**Leigh Anne and Phil Francis**  
**Comments on Separating Freight and Bike Travel**

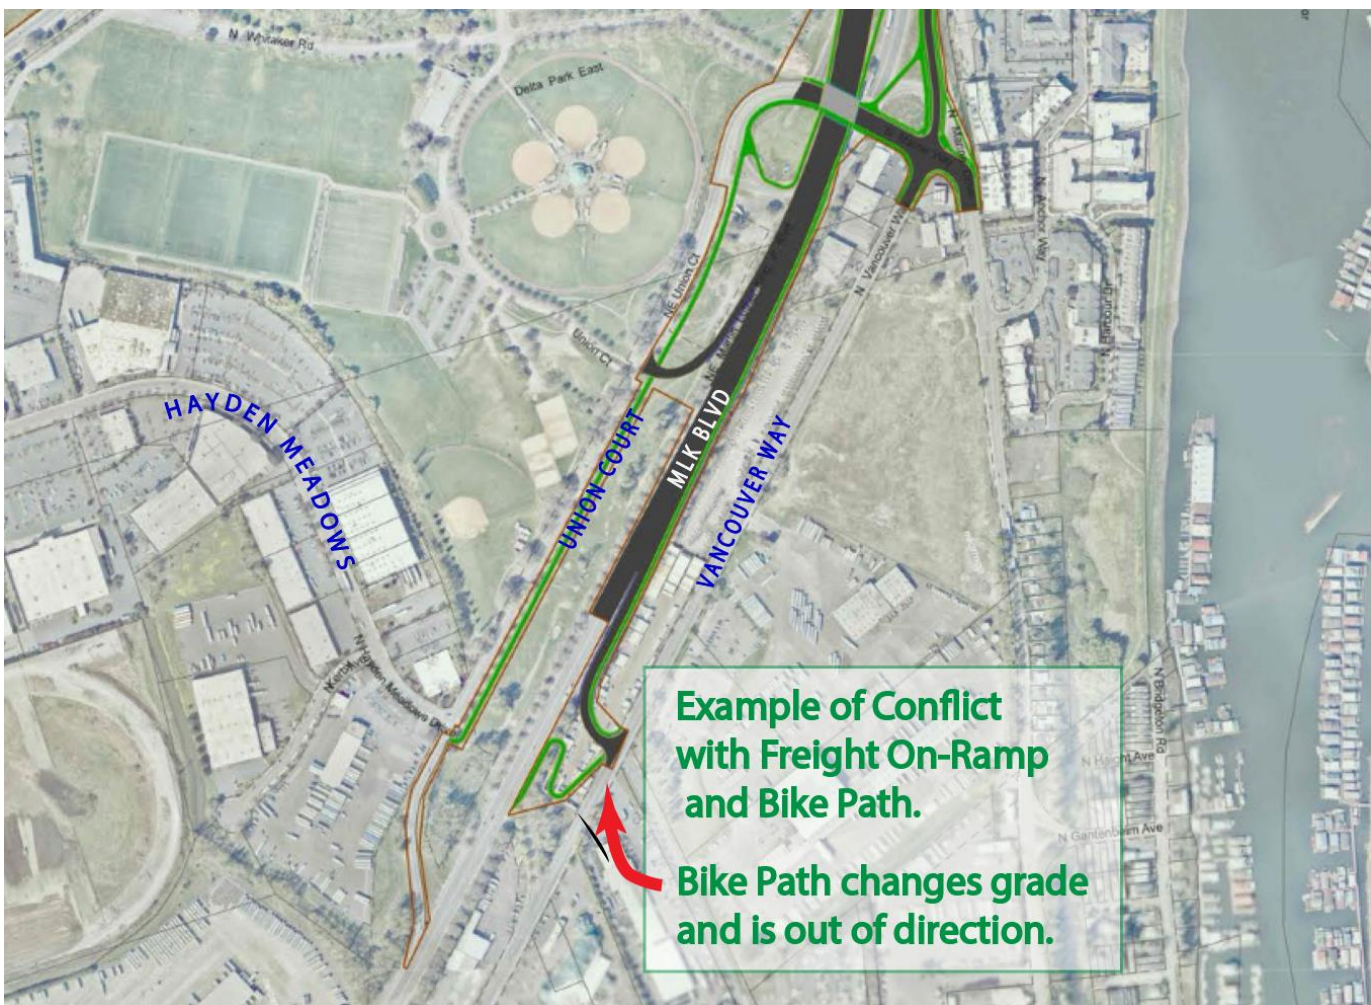
The proposed IBR design for the ramp from Vancouver Way to MLK North poses significant conflict between Freight and Bikes, as the proposed Bike route travels changes grade along a switch back, crosses a major Freight intersection and climbs a grade up along a freight-heavy on-ramp.

Another example of possible Freight-Bike conflict is in the Marine Drive Interchange. Here IBR proposes to build a complete bike lanes and pedestrian sidewalk on both sides of the Interchange.

Even if the IBR is required by State Law to provide bike and pedestrian facilities on the Marine Drive interchange, we recommend additional study on improving two aspects of these improvements:

- 1) Any facilities for bike and ped that must be built on Marine Drive needs to be built in a way that separates bike and ped travel from Freight as much as possible using techniques such as barriers, and raised bike roadways.
- 2) To discourage any active transportation users from crossing the Marine Drive interchange, also build alternative routes that go around the Marine Drive Interchange rather than through the interchange. This separate bike ped system needs to be so well design that it becomes the preferred route. Current IBR design has the MLK active user connection provided partially along MLK shoulders and partially on separated trails. To become the preferred route, an active transportation route that is not reliant of MLK shoulders need to be developed. This separated preferred corridor needs to conveniently link to each of the existing regional bike corridors.
